**CONTRACT DOCUMENTS & TECHNICAL SPECIFICATIONS
ADDENDUM NO. 5**

**DELAWARE BAYSHORE BYWAY
LITTLE CREEK BOARDWALK AND WILDLIFE VIEWING TOWER
CONTRACT NO. FW-2-15**

Contract No.: FW-2-15

Date of Issue: February 27, 2018

1 Railing Elevation Detail
1-1/2"=1'-0"

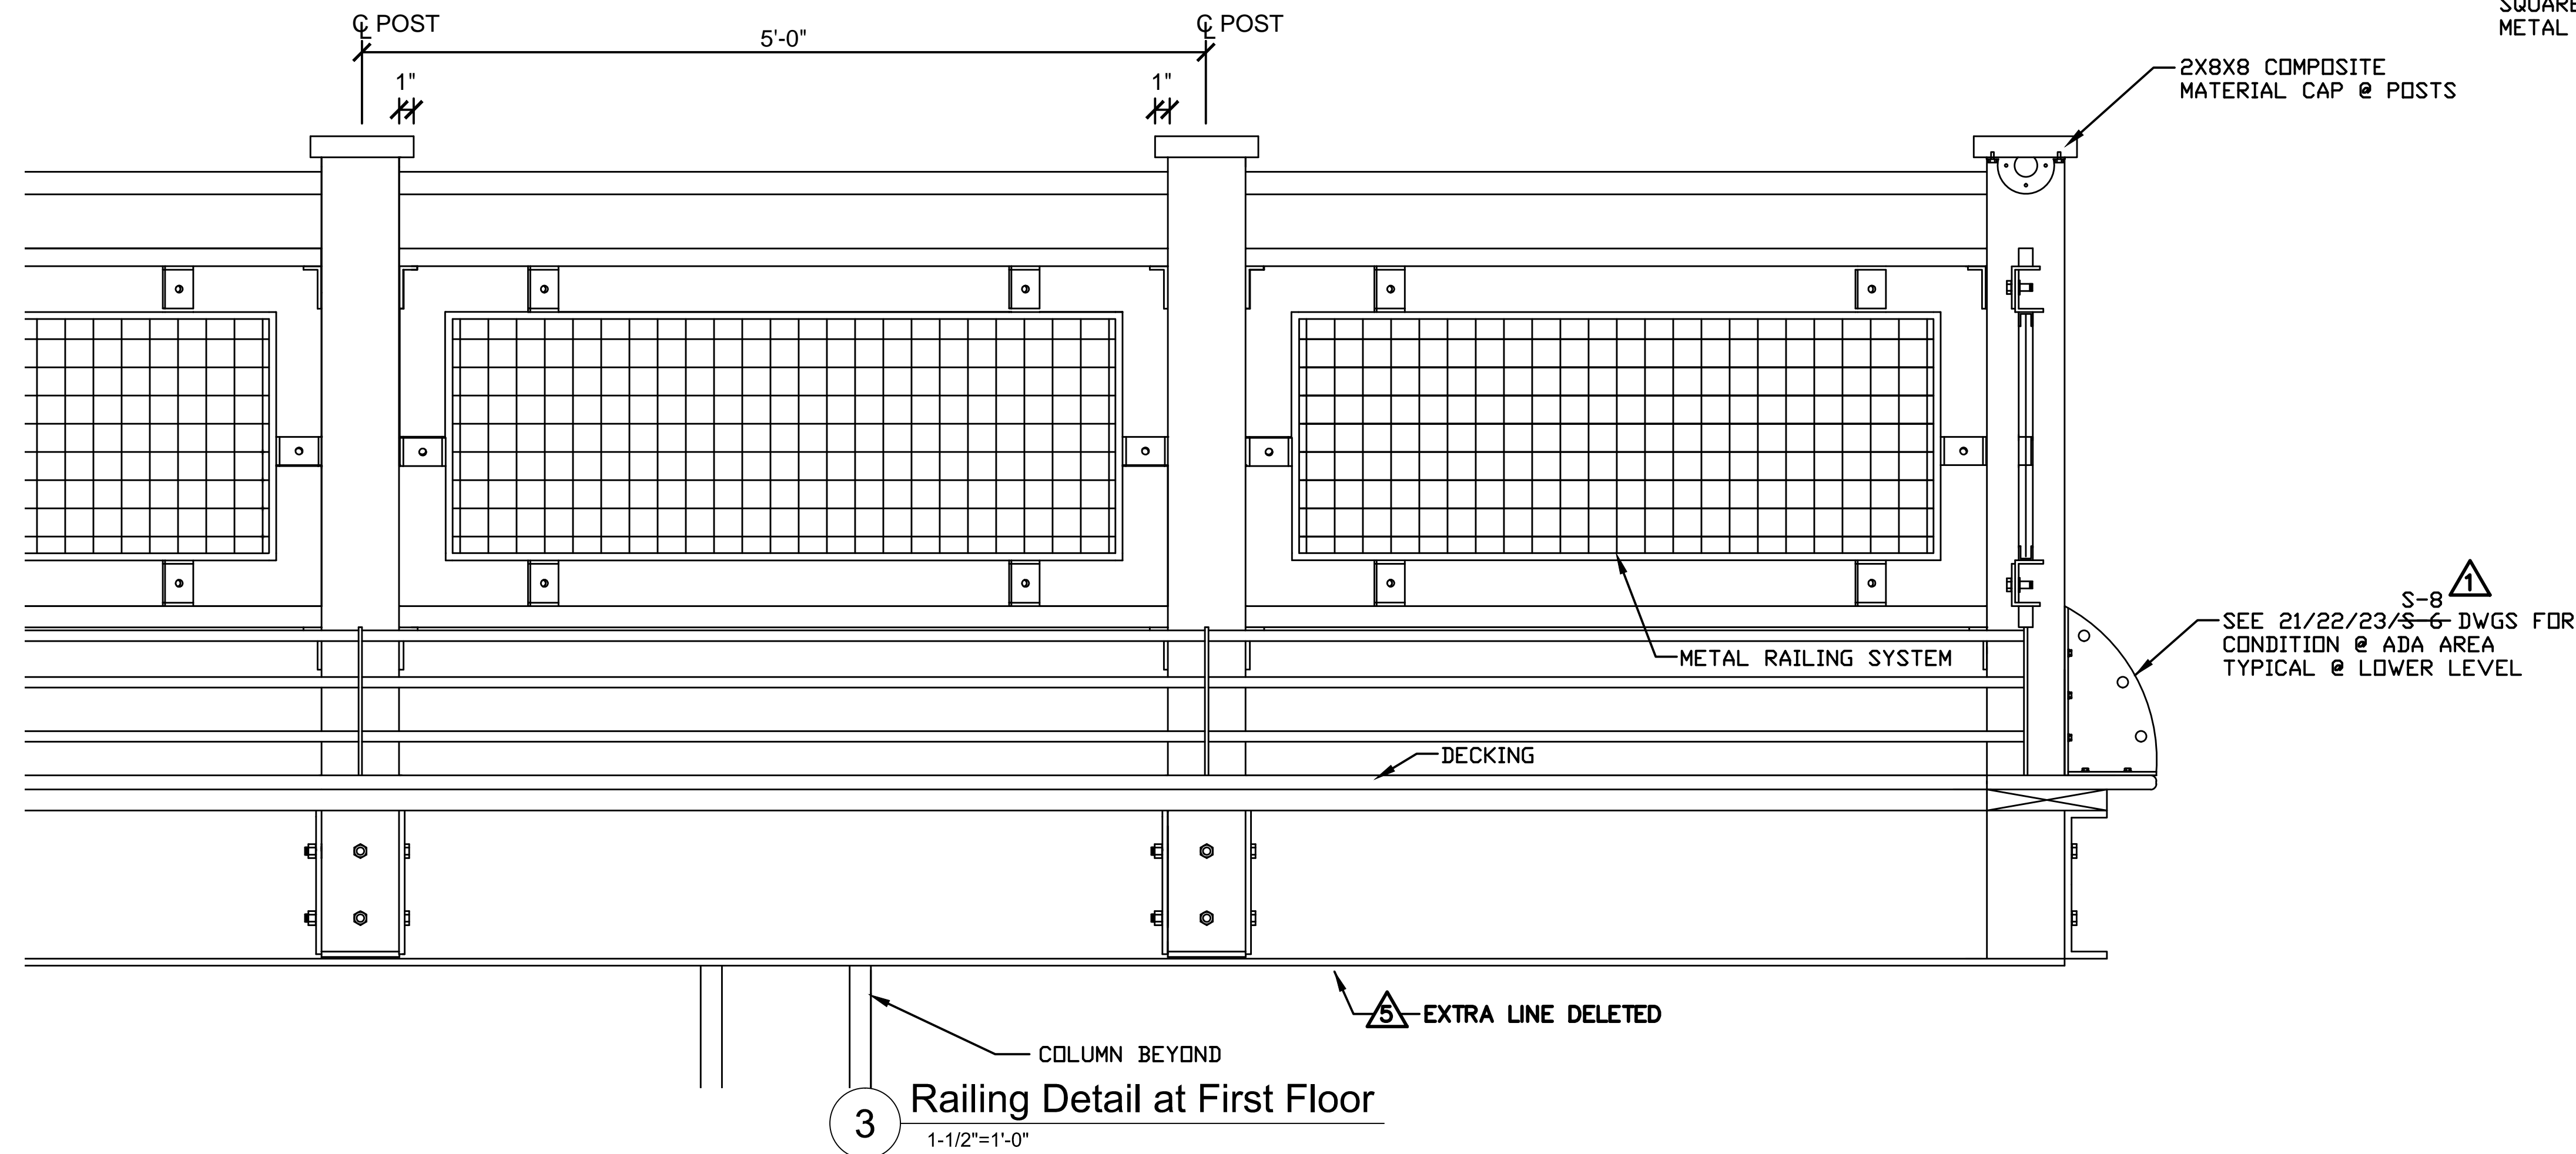
Q41. On Drawing A-4, Detail 1 & 3, there is a double line underneath the perimeter channel, what does this double line represent? Does the bottom of 2x2 Wood joist get covered or stay exposed? Please clarify.

A41. Drawing A-4, Details 1 & 3 shall be revised to eliminate the double line. The joist shall be exposed.

7 Observation Tower First Level Framing Plan

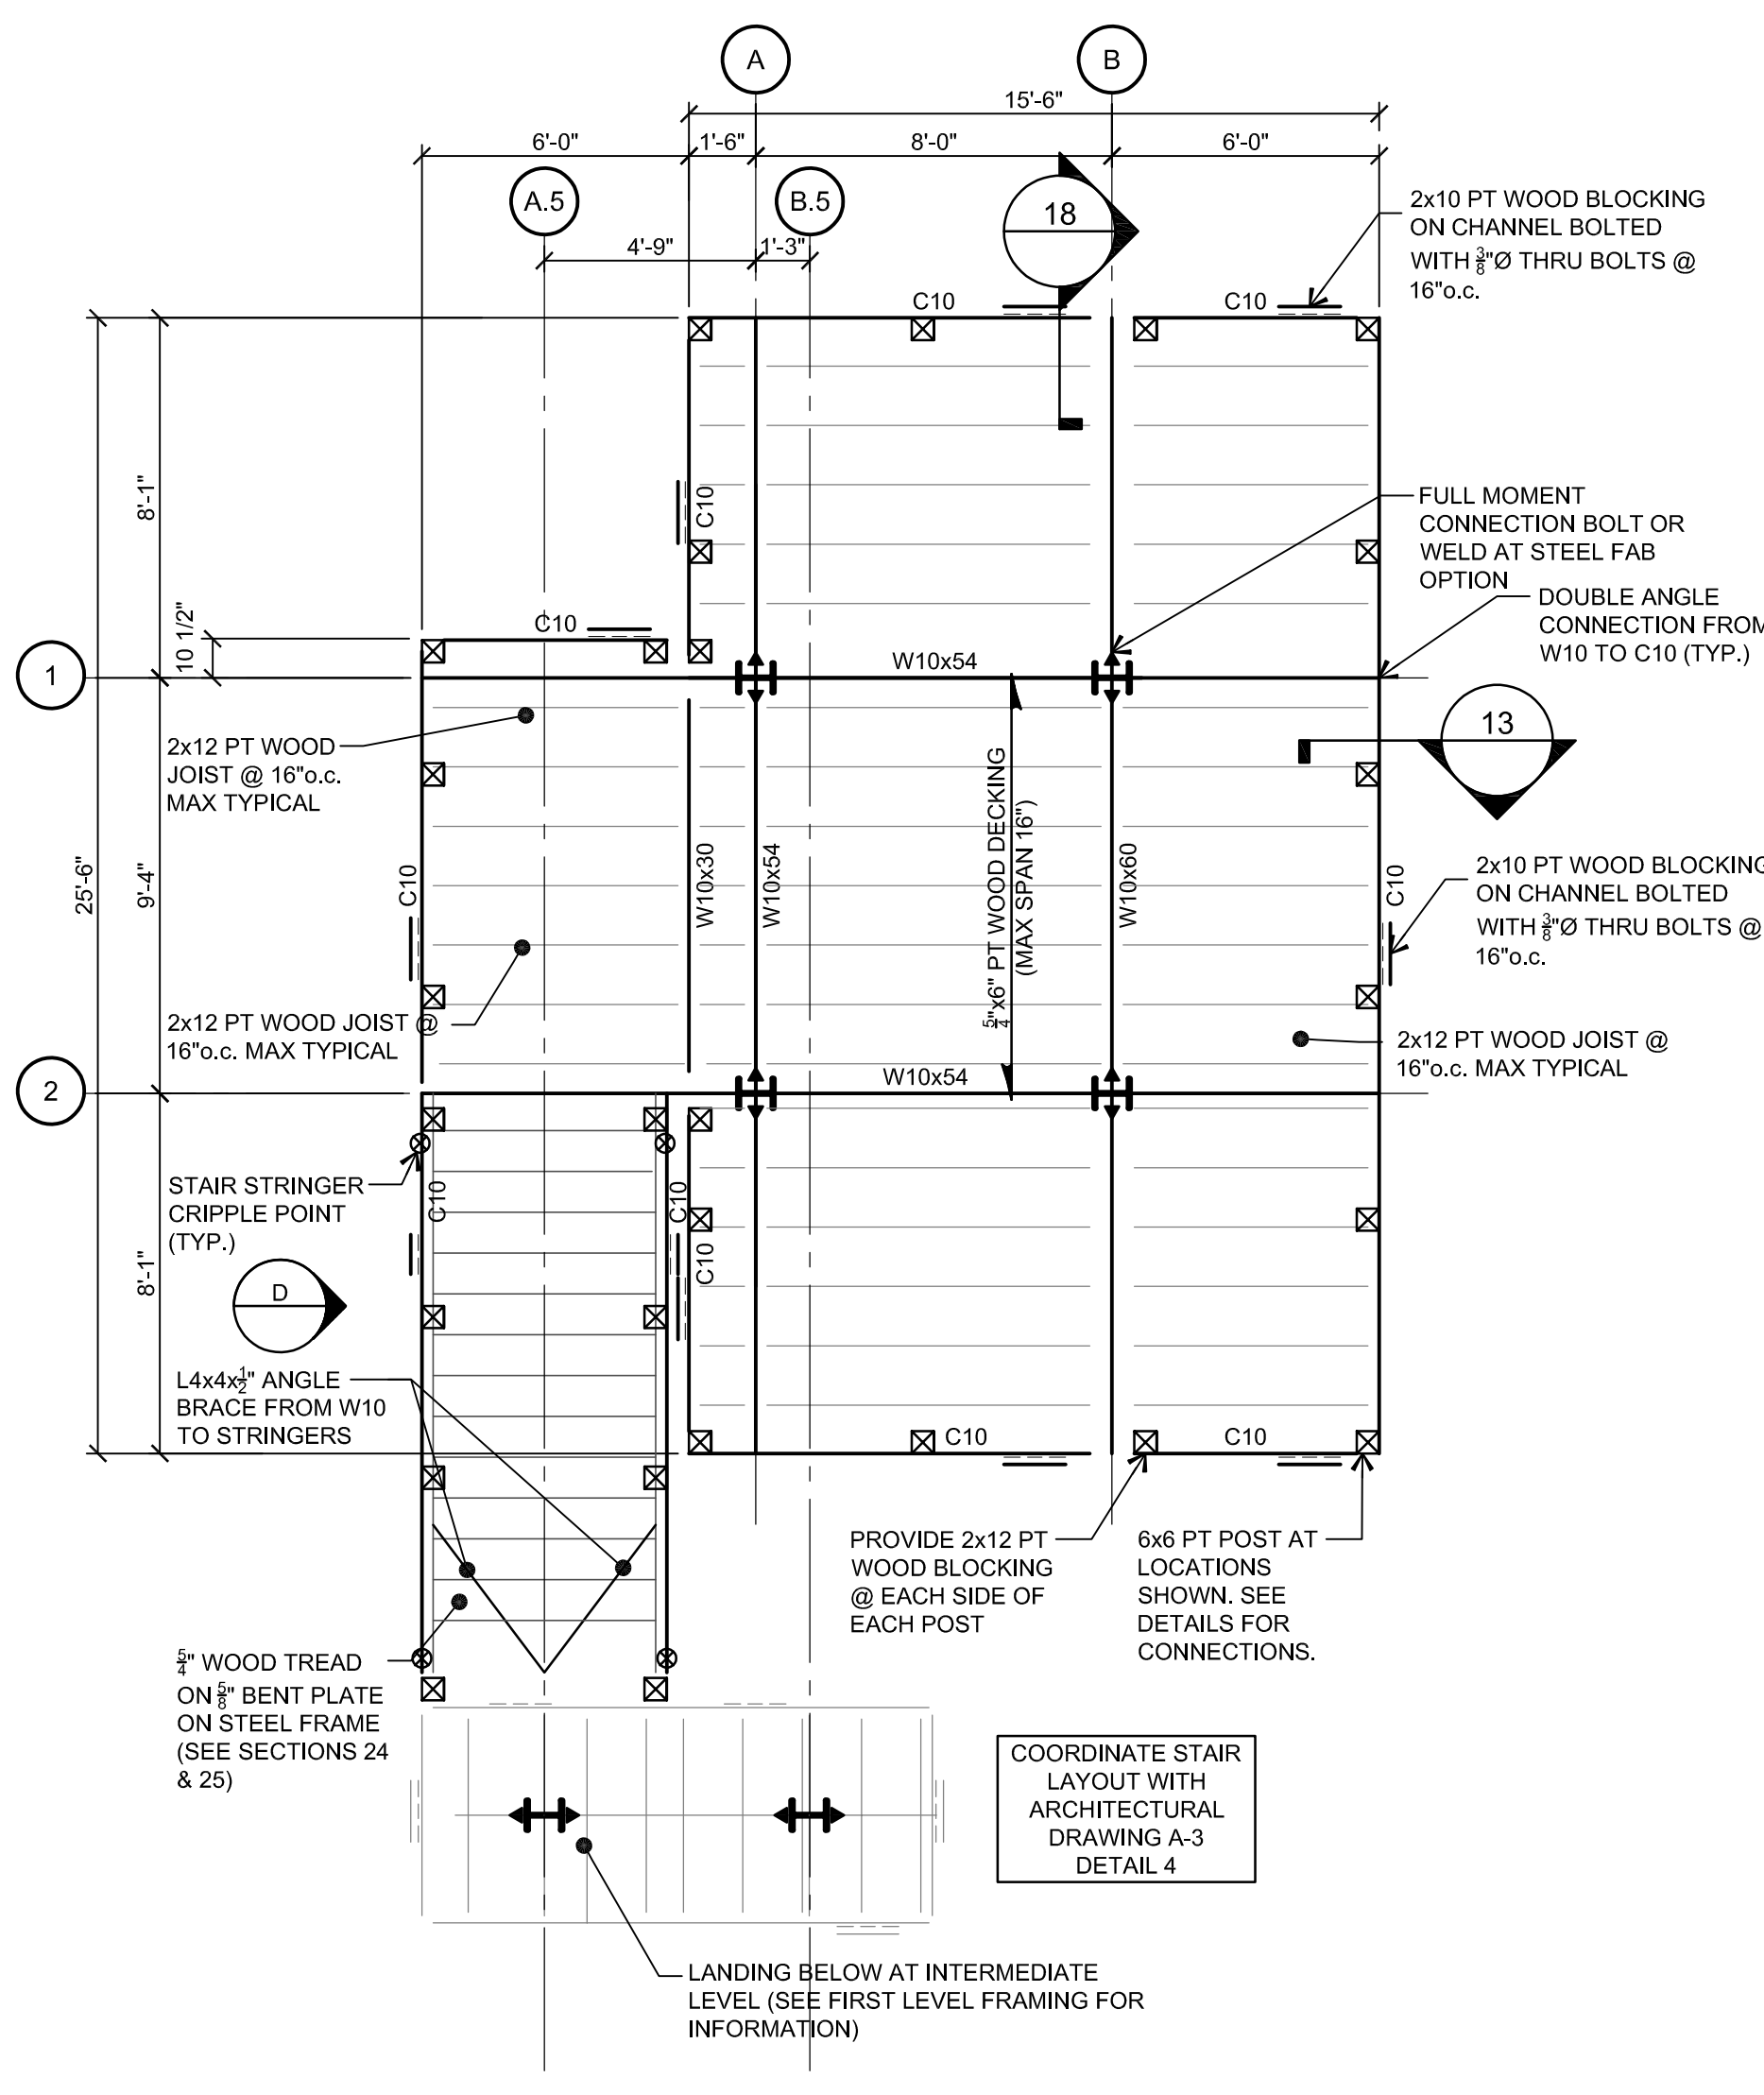
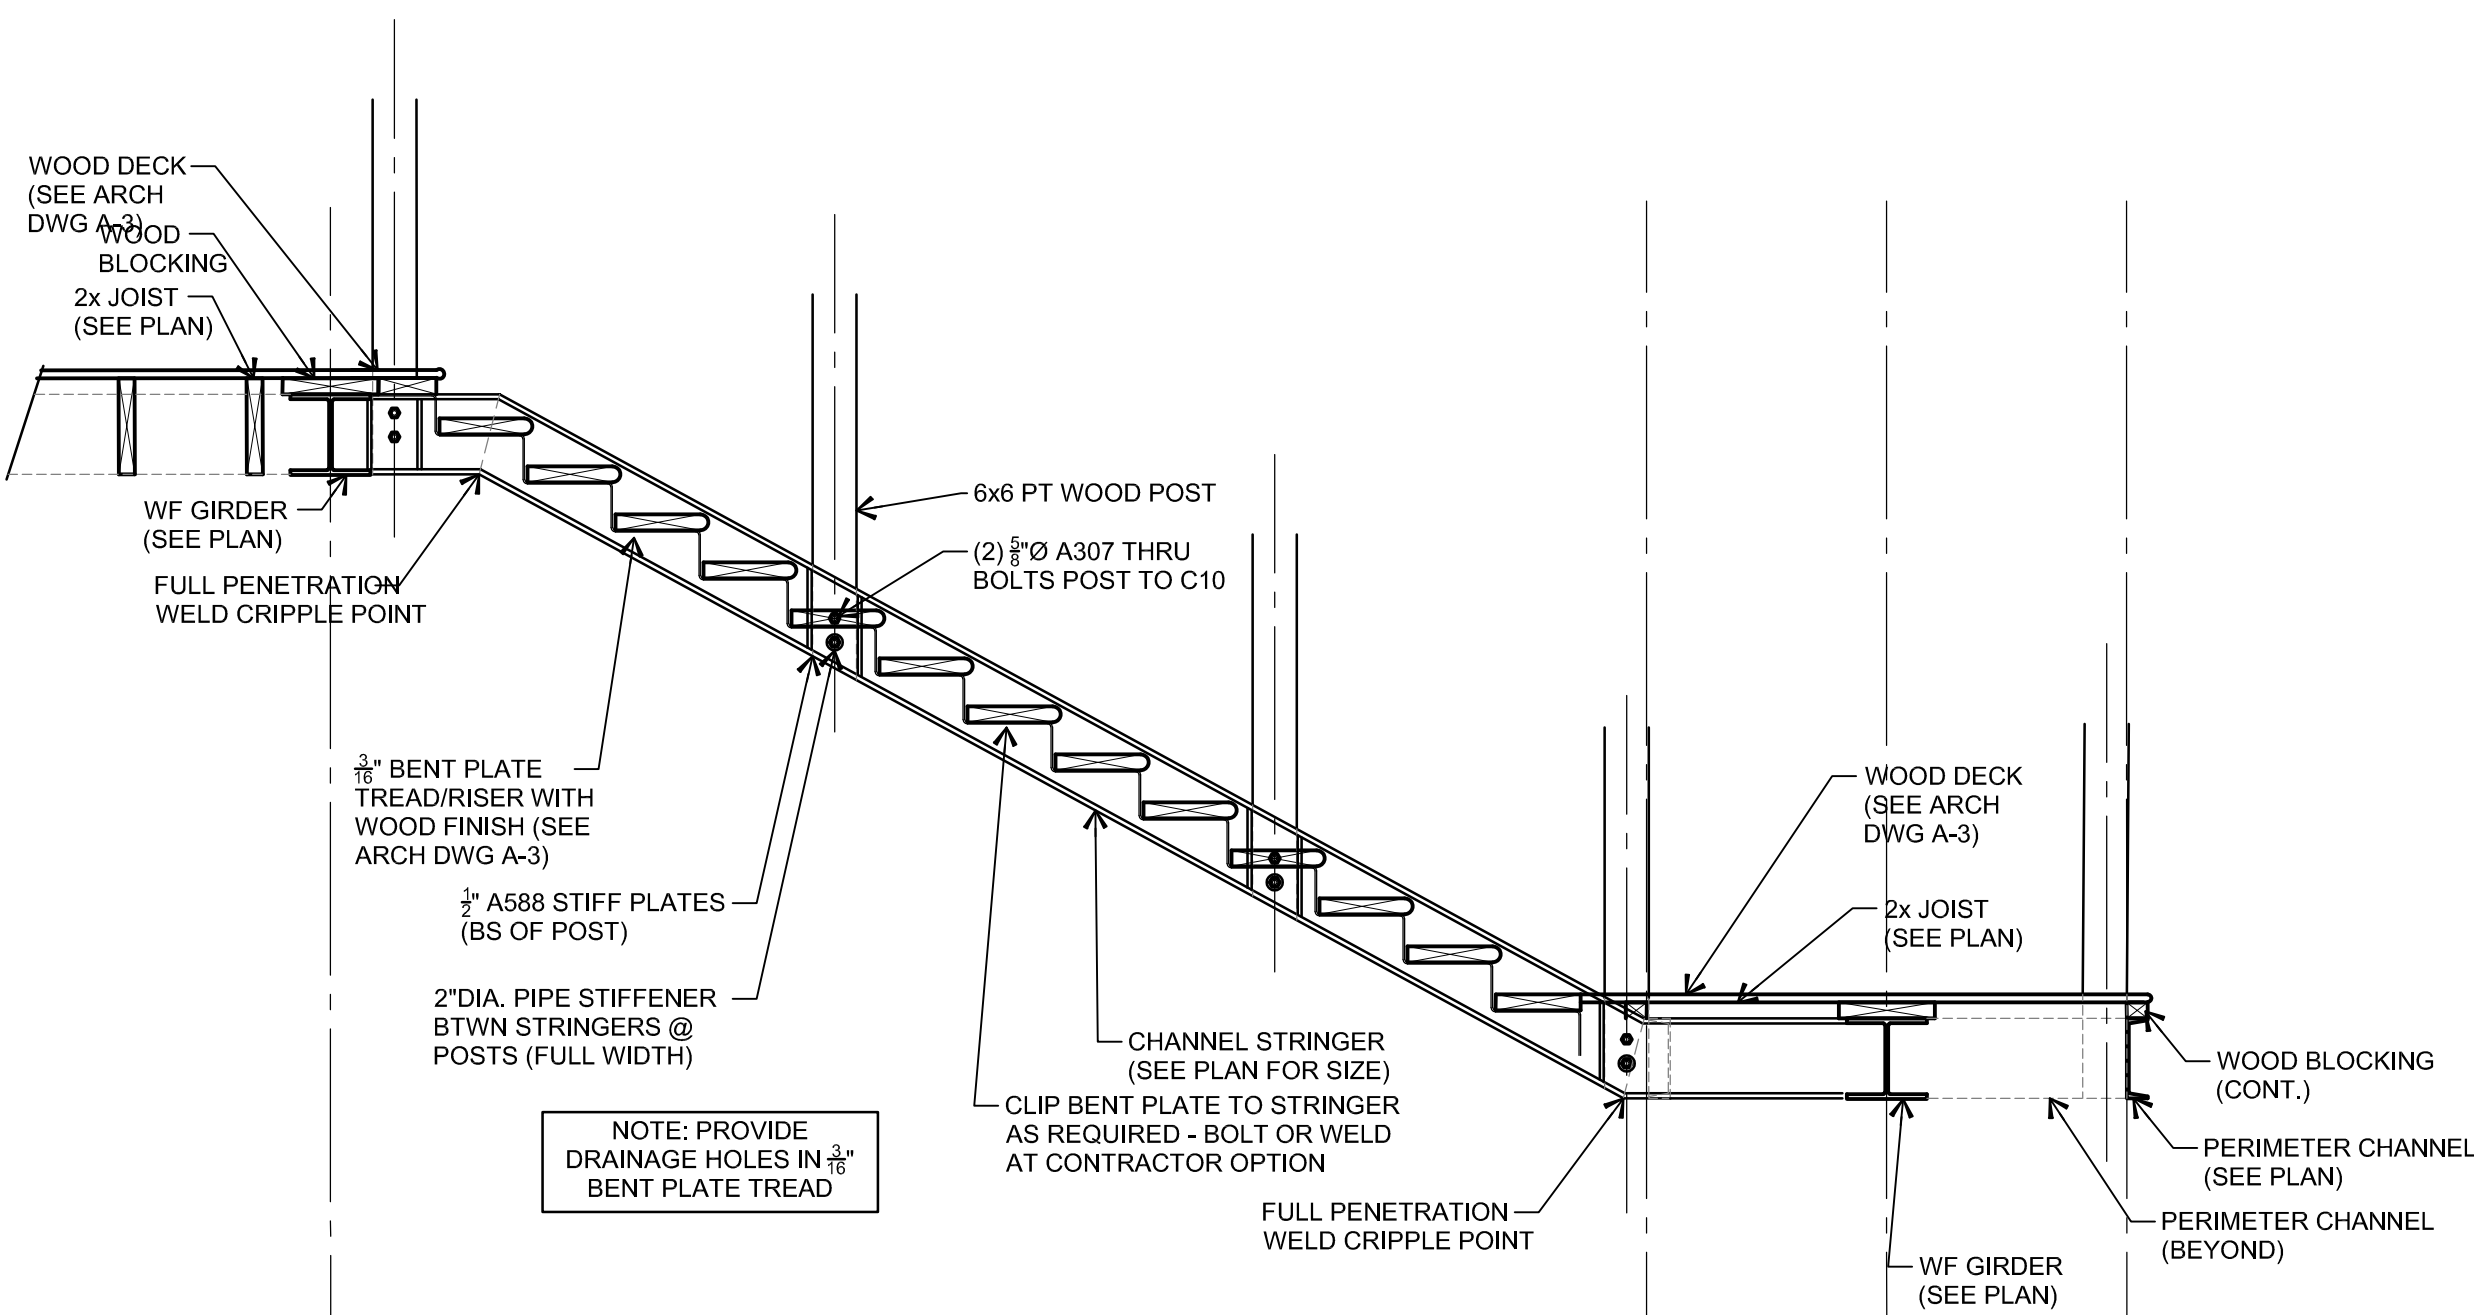
Q26. At the observation tower on drawing S-6, for the first and second level we need a detail on how to attach the 2x12 flooring joist to the 10x60 beam.

A26. See Note 10 on the Framing Plans for information regarding the connection.
